Access Compliance Report

Public Rights-of-Way

(Curb Ramps)

Intersection ID: 42959	Main Street: APPLE_DOVE_CT	Cross Street: QUAIL_ST	Location: NE
ADA ID: 53DCAE867168	Ramp Type: PerpDiag	Initial Pass/Fail: Fail	Overall Compliance: No
Codes/Mitigation Info/Possible Solution		Field Measurements/Component Compliance	
Severity Score: 33.75

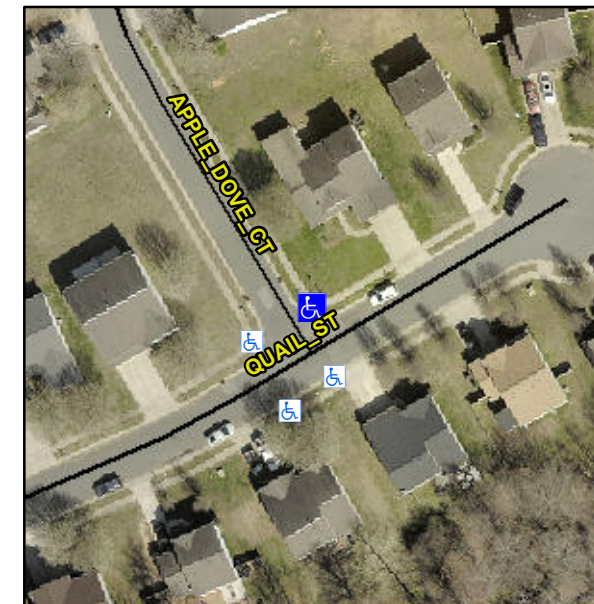
Compliance	Description	Data	Compliance	Description	Data
N/A	Ramp Length (in)	49.5	No	Ramp Slope (%)	9.6
No	Ramp Width (in)	42.0	No	Ramp XSlope (%)	6.9
N/A	Flare Type LT	N/A	N/A	Flare Type RT	N/A
N/A	Flare Slope LT (%)	N/A	N/A	Flare Slope RT (%)	N/A
N/A	Flare Traversable LT?	N/A	N/A	Flare Traversable RT?	N/A
N/A	Landing Length (in)	N/A	N/A	DWS Provided?	N/A
N/A	Landing Width (in)	N/A	N/A	DWS Contrast?	N/A
N/A	Landing Slope (%)	N/A	N/A	DWS Length (in)	N/A
N/A	Landing X Slope (%)	N/A	N/A	DWS Full Width?	N/A
N/A	Landing Curb? (Y/N)	N/A	N/A	DWS Offset (in)	N/A
N/A	Shared Landing?	N/A			
N/A	Gutter Ponding?	N/A	N/A	Gutter Slope (%)	N/A
N/A	Gutter Lip Ht (in)	N/A	N/A	Gutter X Slope (%)	N/A
N/A	Painted X Walk1?	No	N/A	Painted X Walk2?	No
	X Walk 1 Direction	To W		X Walk 2 Direction	To S
N/A	X Walk 1 Width (in)	N/A	N/A	X Walk 2 Width (in)	N/A
	X Walk 1 Slope (%)	1.7		X Walk 2 Slope (%)	0.4
	X Walk 1 X Slope (%)	3.0		X Walk 2 X Slope (%)	3.3

N/A	Ramp inside XWalk1?	N/A	N/A	Ramp inside XWalk2?	N/A
	Road Slope (%)	5.0	N/A	Clear Space?	N/A
	Road X Slope (%)	2.3	N/A	Clear Space to XWalk (in)	N/A
N/A	Any Obstructions?	N/A	N/A	Storm Grate/Utility Hazard?	N/A
	Obstruction Type			Storm Grate/Utility Type	
		N/A			N/A
			Yes	Surface Condition? (G/P)	Good

Remove & Replace Curb Ramp With Two New Directional Ramps or Equivalent.
